Design Recommendation Meeting Packet DPD # 3020943

1200 Stewart St.

PURPOSE OF REPORT

On November 17, 2015 the Design Review Board provided Final Early Design Guidance on the 1200 Stewart Street project. The purpose of this Packet and the presentation is to illustrate to the Board at the Recommendation Meeting how our current design proposal has responded to that guidance.

View from Denny Way Looking Southwest

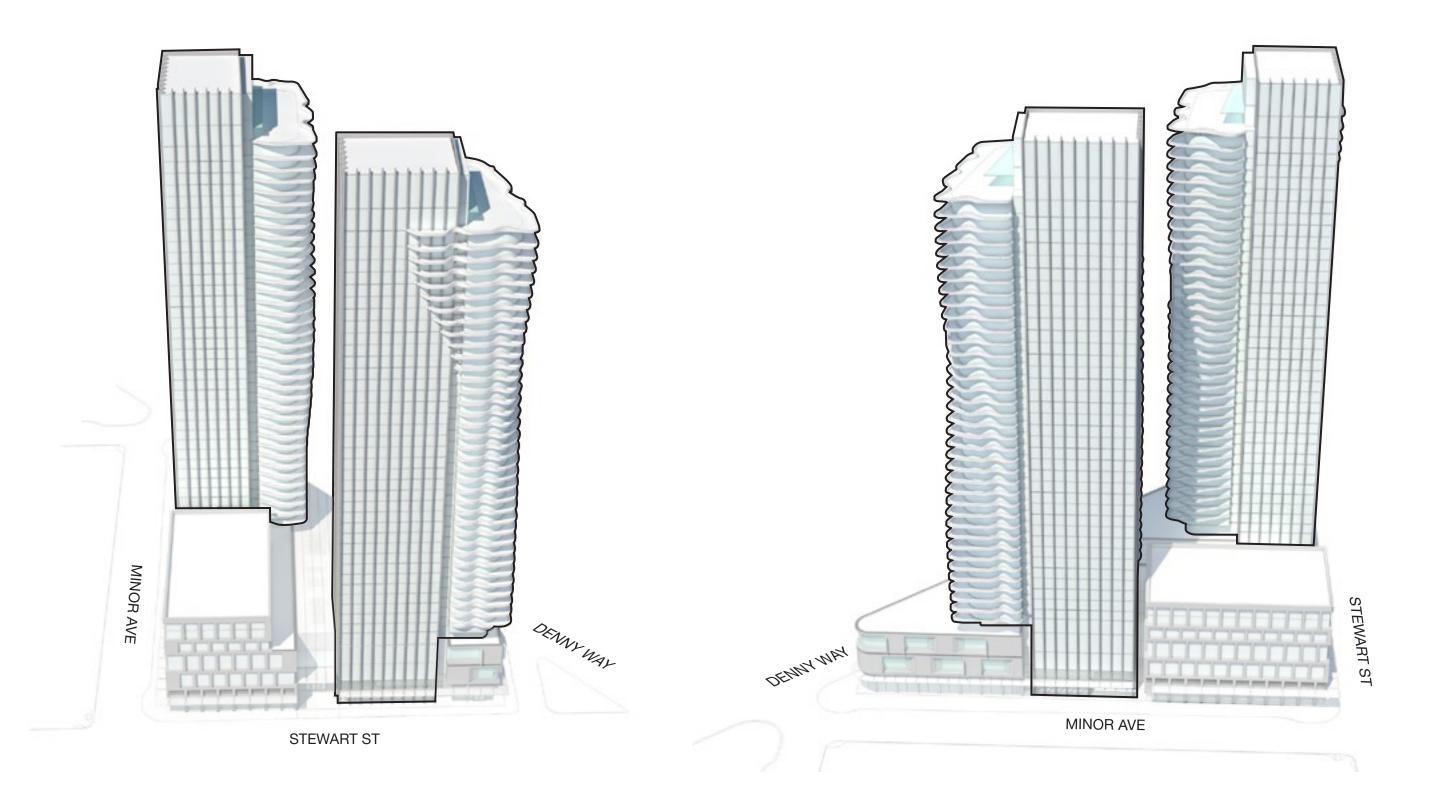
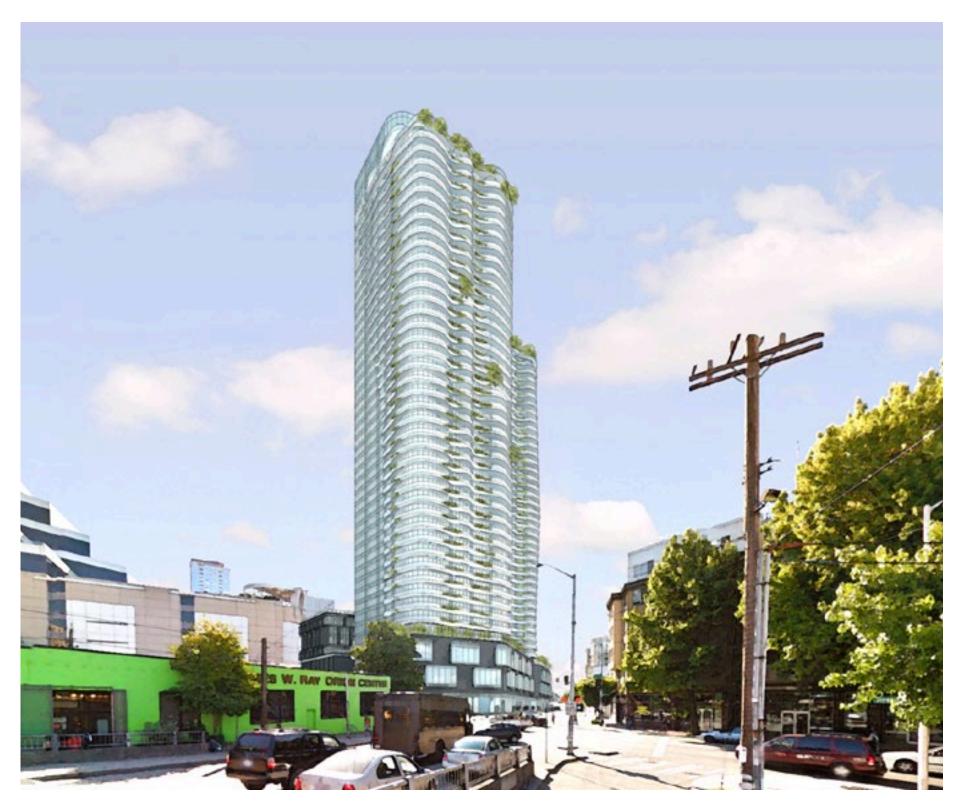
The Board supported the undulating balconies and was pleased that the tower forms were sculpted and nonrectilinear. However, they noted that the horizontal curved balconies and vertical skin articulation of the 'core' were competing design elements and observed that the towers were too small for the two different tower elements to work successfully. The Board gave guidance to unify the design, remarking that the design as shown on the left graphic on page 61 of the EDG packet showed an articulated, well unified design. (A2.1, B4)

- **1a.** Design the towers with a unified articulation. (B4)
- 1b. Study how the fluid shape of the balconies will terminate at the 'core.' (B4.2 &3)
- **1c.** Consider extending the undulating form around the tower with balconies, the exterior skin or a secondary element plants can grow from. (B4)
- 1d. Consider the use of light colored glass or horizontal elements as a way to merge the undulating and rectilinear planes of the tower. (B4.2 &3)

- **1a.** Design the towers with a unified articulation. (B4) The towers have been redesigned with a unified articulation by increasing the horizontal expression.

- 1b. Study how the fluid shape of the balconies will terminate at the 'core.' (B4.2 &3) The fluid shape of the balconies now appear to
 - blend into the horizontal glass spandrel of similar colour and proportion.

- 1c. Consider extending the undulating form around the tower with balconies, the exterior skin or a secondary element plants can grow from. (B4)
 - Since the balcony slab extensions are thermal bridges, extending the undulating form of the balconies around the tower is not advisable from a sustainability perspective. A similar result can be created by blending the horizontality of the balcony with the horizontality of the glass spandrel.

- 1d. Consider the use of light colored glass or horizontal elements as a way to merge the undulating and rectilinear planes of the tower. (B4.2 &3) This was done.

View from Denny Way Looking East

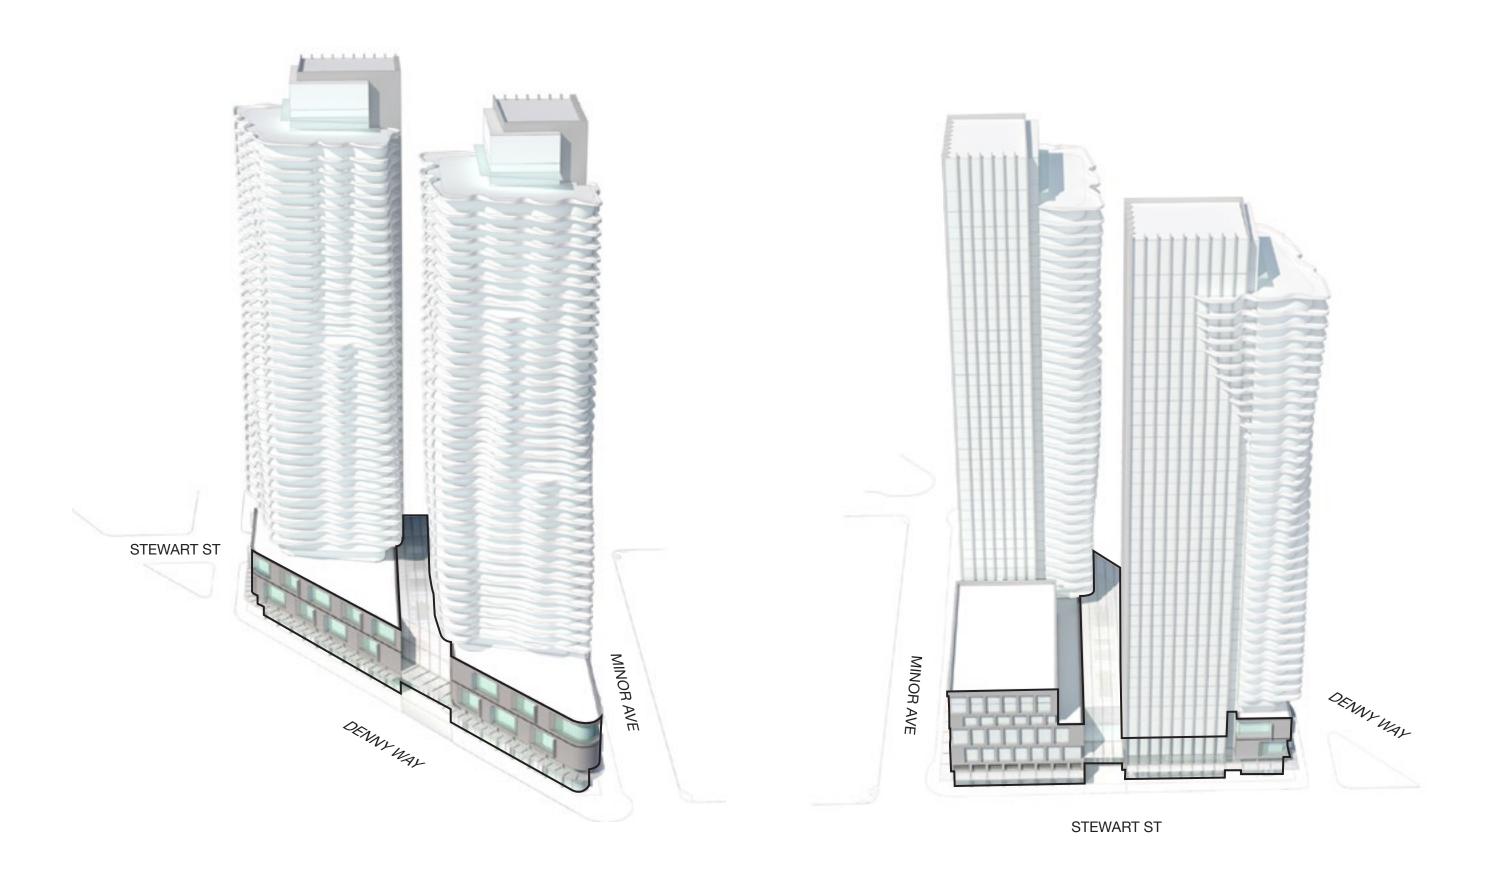
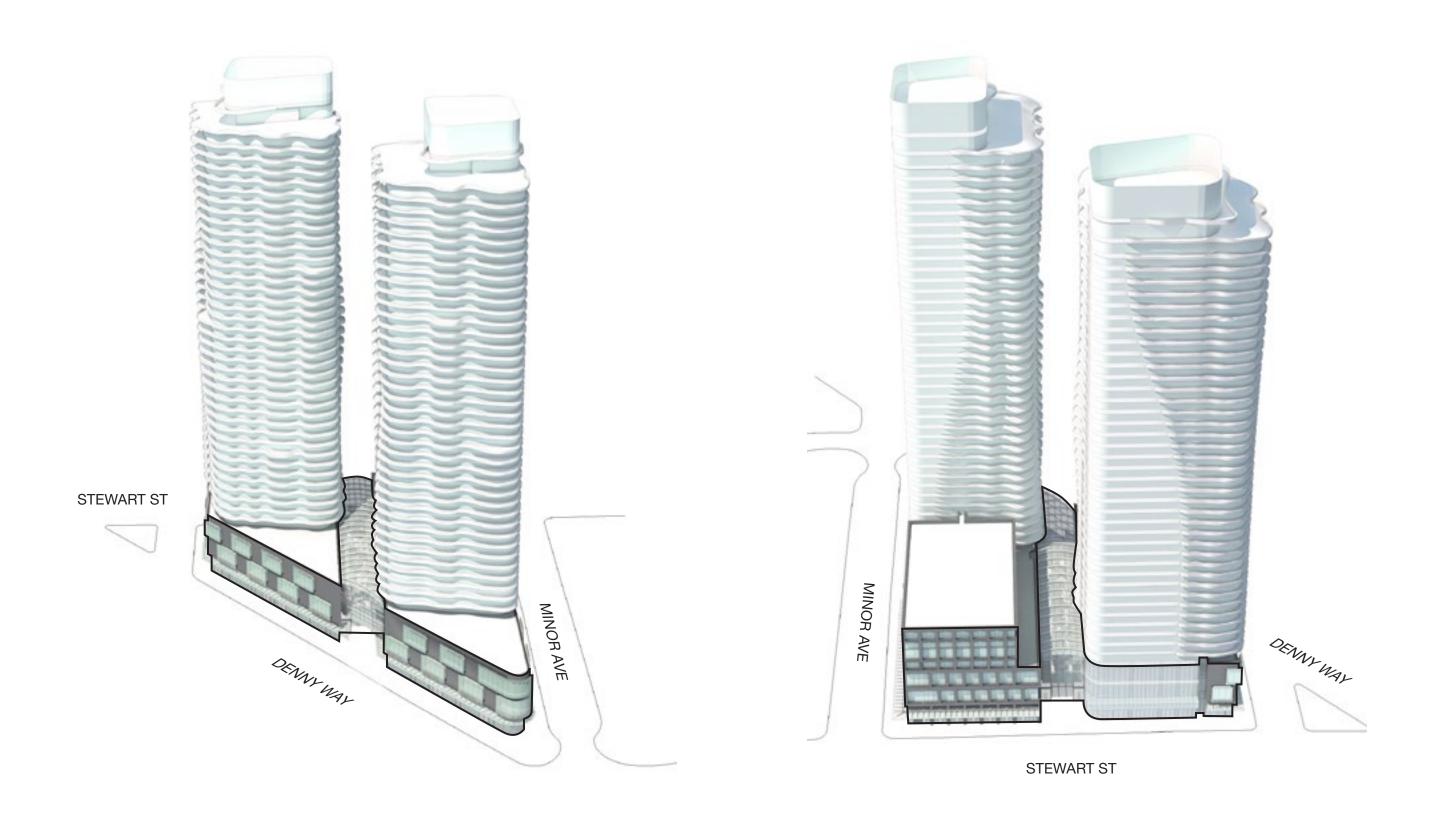
The Board stated that the lower podium was an improvement from the previous design. The Board did express that the pairing of the curved 'flat iron' at the podium and the curved tower above, at the intersection of Denny Way and Minor Ave, did not make a strong design statement. (B4.1 & 2) The following guidance was given:

- 2a. Design the podium 'flatiron' at Denny Way and Minor Avenue with greater contrasts to the tower above to provide a powerful corner design. (B4.1 & 2)
- 2b. Provide a porous edge between the commercial space and circulation space of the galleria (B4.2& D1)
- 2c. Relocate the south tower residential entry and lobby and provide commercial space along the galleria (C1.1 &2)
- **2d.** Provide more developed retail concepts. Explore a market type' or porous edge at the galleria. (B4.2)

- 2a. Design the podium 'flatiron' at Denny Way and Minor Avenue with greater contrasts to the tower above to provide a powerful corner design. (B4.1 & 2) Greater contrast between the Tower and Podium is provided by choices in color and materiality. The juxtaposition between the charcoal glazed brick and the protruding structural glass display windows of the Podium, against the white undulating balconies and Curtain Wall of the Tower above provides a strong contrast. The addition of overlapping structural glass display windows on multiple levels of the flatiron further contributes a powerful corner design.

- 2b. Provide a porous edge between the commercial space and circulation space of the galleria (B4.2& D1) The galleria has been further developed to be an unconditioned interior street. The extensive storefront glazing providing increased porosity.

- 2c. Relocate the south tower residential entry and lobby and provide commercial space along the galleria (C1.1 &2) Both residential lobby entries have been taken off the street for more storefront continuity, and are now accessed off the Galleria for more animation.

- **2d.** Provide more developed retail concepts. Explore a market type' or porous edge at the galleria. (B4.2) Both the Retail and Galleria concepts have been developed. See Section 3.3.1 and 3.3.2.

View from corner of Stewart Street & Denny Way

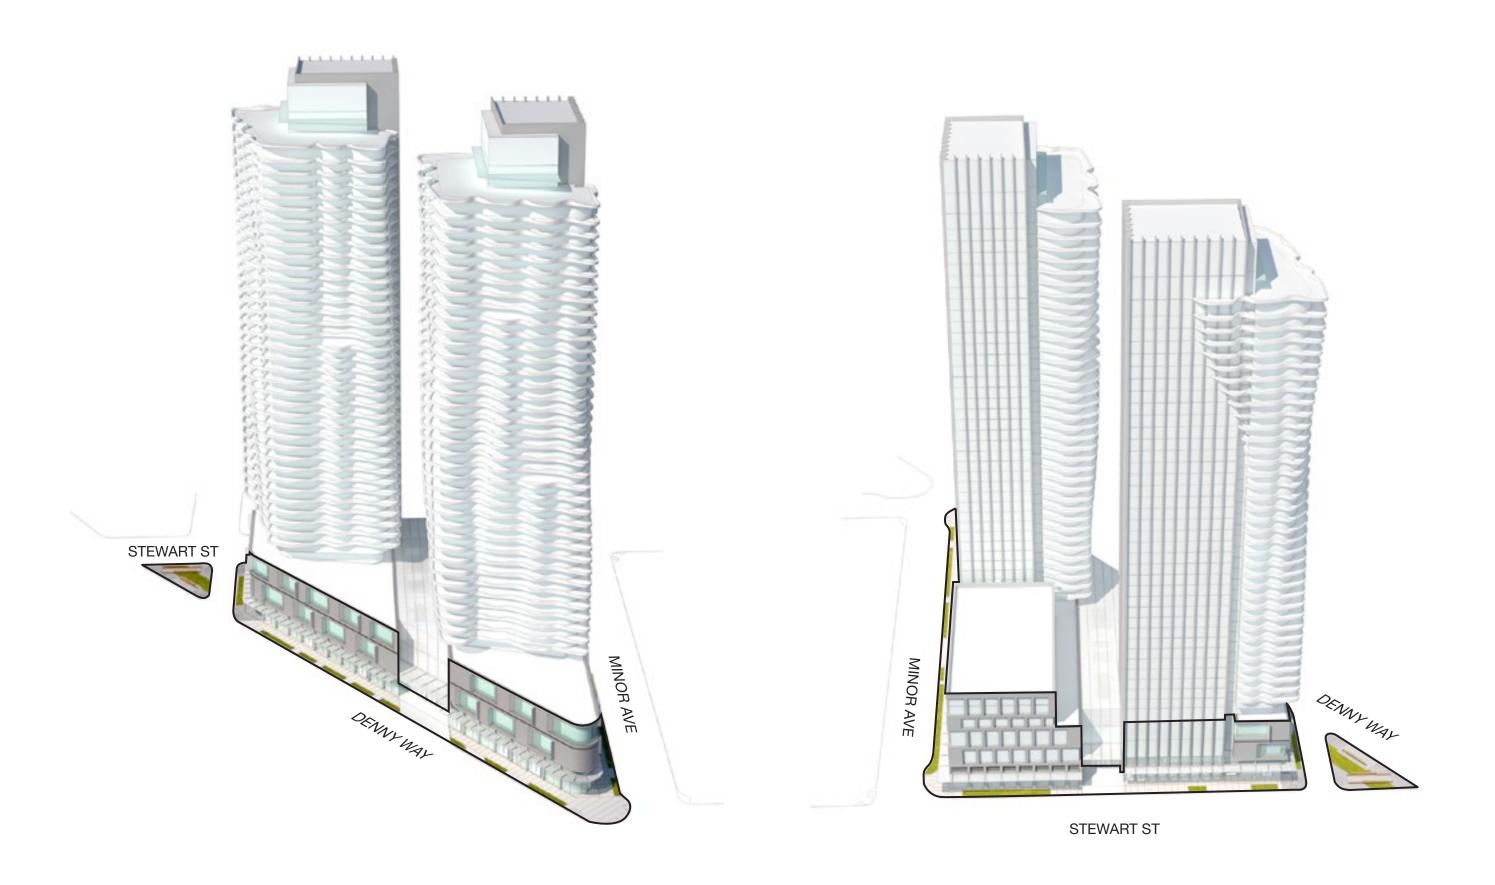
The Board expressed support for the evolution of the design, noting it was a much stronger scheme then the previous project, especially with the changes made on the ground floor, the added retail space and removal of the port cochere. The Board gave guidance to incorporate aspects to the previous design, which included more generous public space, and provide more area for spill out along the street edges. (C1, D1)

- 3a. Provide a more porous street edge with space for spill out of retail uses. (C1.2)
- 3b. Encourage locating retail at the galleria corner and relocating the south tower residential entry. (B4.2)
- **3c.** Provide a more generous outside public zone. (C1 & D1)
- **3d.** Study the use of the triangular island in the ROW to the east of the site and develop a design that integrates with the project (D1.1 & 2)
- **3e.** Provide detailing of the proposed landscaping, public art and finishes in the ROW. (D1.2)

- 3a. Provide a more porous street edge with space for spill out of retail uses. (C1.2) The pedestrian experience is enhanced by open facades, multiple building entries, display windows, street furniture and landscaping.

- 3b. Encourage locating retail at the galleria corner and relocating the south tower residential entry. (B4.2) Retail exposure on the street has been increased at the Galleria entry, by moving the residential lobby entries inside the Galleria.

- **3c.** Provide a more generous outside public zone. (C1 & D1) In addition to the generous amount of exterior public space that has been provided by the Public Benefits, the Galleria can be seen as a safe, protected extension of the public realm.

- **3d.** Study the use of the triangular island in the ROW to the east of the site and develop a design that integrates with the project (D1.1 &2) Refer to the Landscape Section 5.1 and 5.2.

- 3e. Provide detailing of the proposed landscaping, public art and finishes in the ROW. (D1.2) Refer to the Landscape Section 5.1 and 5.2.
